8-10 C-VE STREET (EAST)

PERMIT TO INSTALL PLUMBING

CITY OF PORTLAND, MAINE

8-10 East Cove St.

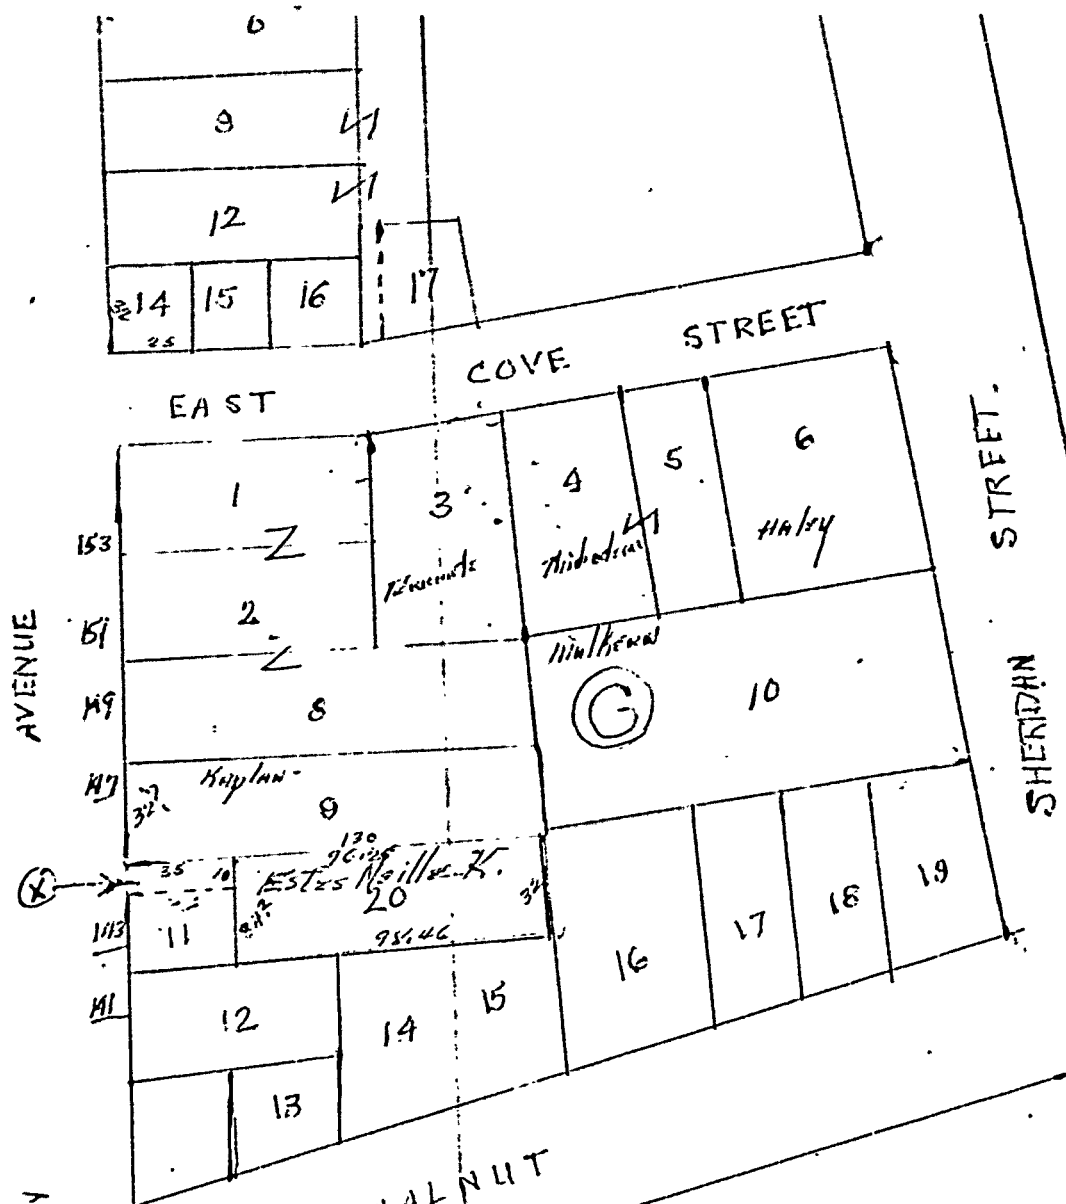
THE DEED'S
SHOULD BE READ
ON ALL adjoining PROPERTIES
to be CERTAIN THERE ARE
NO AGREEMENTS YRS BACK
FOR A RI for WAY USE -
X → indicates - this appears to
be right of way - maybe
on their deed -
ASSESSORS MAP NO 12 -

WENT PROPERTY PLOTTED: HORIZING 122' DISTANCE
TOWARD EAST CORR STREET REFERENCES ON AERO, BUT
CONSUMING VACANT PROPERTY NOT OWNED LEGALLY.

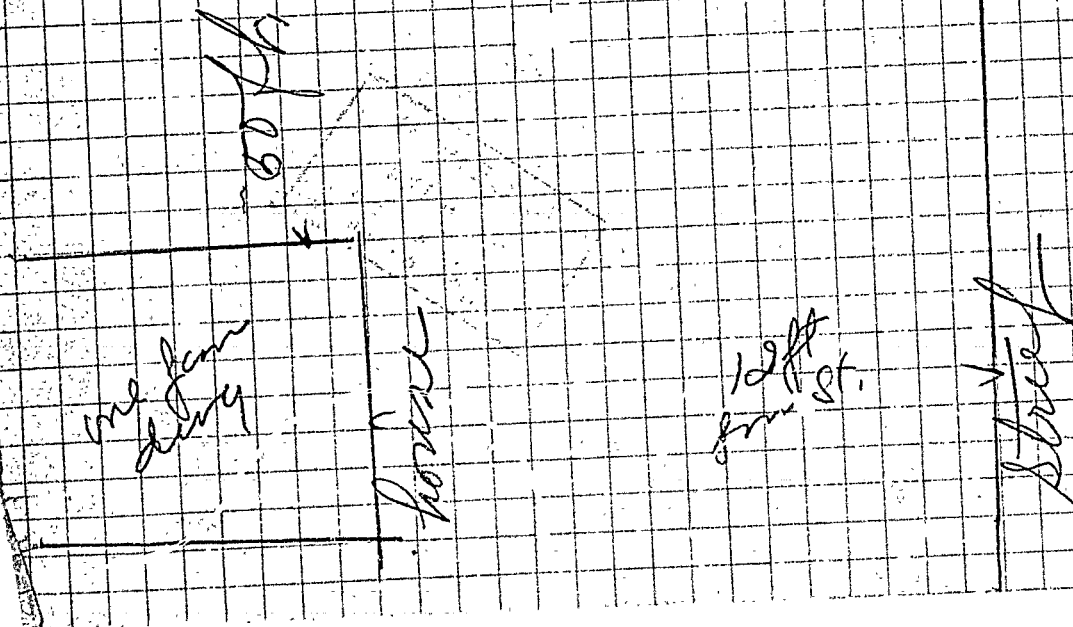
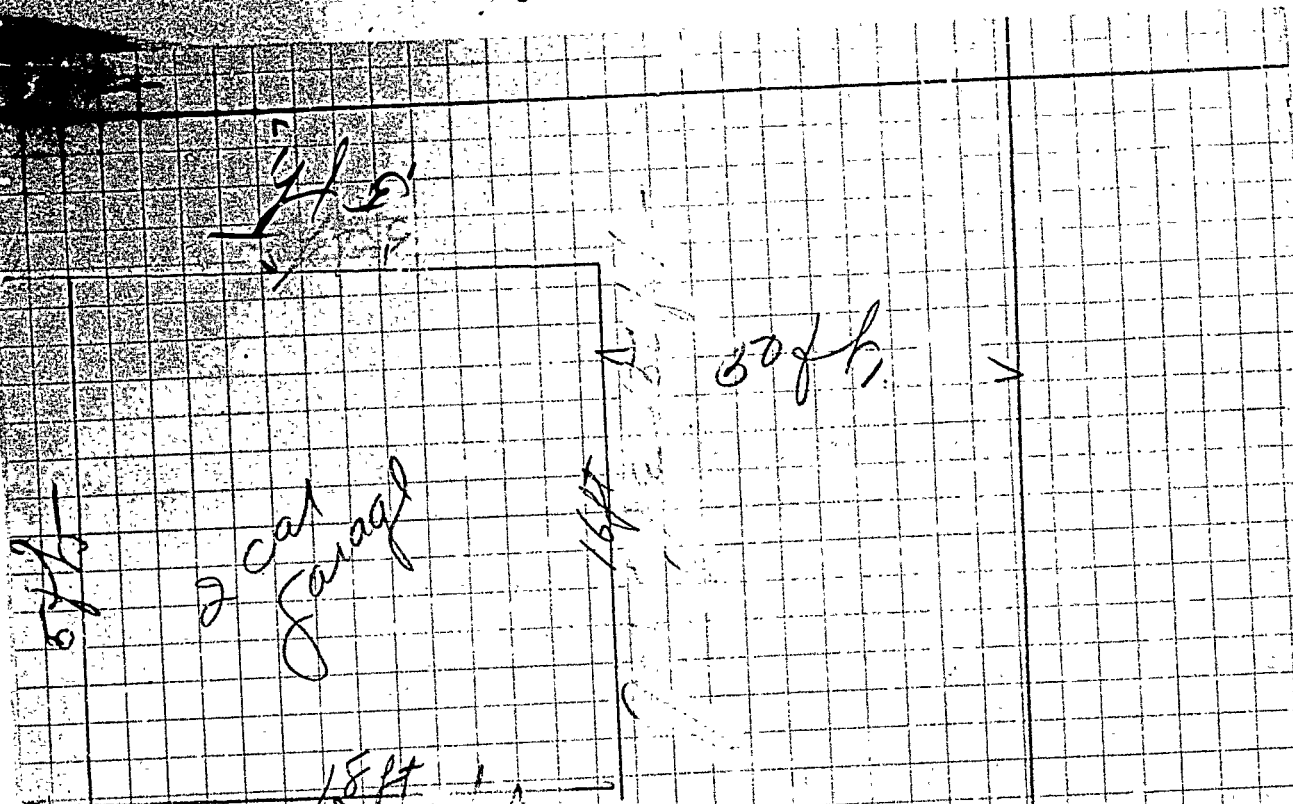
I find that the two car garage which you propose to build for Abraham Moses at No. 12 Cove Street is located within the limits of Fire District No. 1 where a wooden building is not permitted by the Ordinance.

We are, therefore, unable to issue a permit for this wooden garage. The law requires that buildings in the Fire District have their outside walls built of incombustible material through their entire thickness.

If you decide to change the construction of this building to comply with the law, you should come to this office and so indicate upon the application. If, on the other hand, you decide not to proceed with the work and will return the receipt for the fee paid, your money will be refunded by voucher.
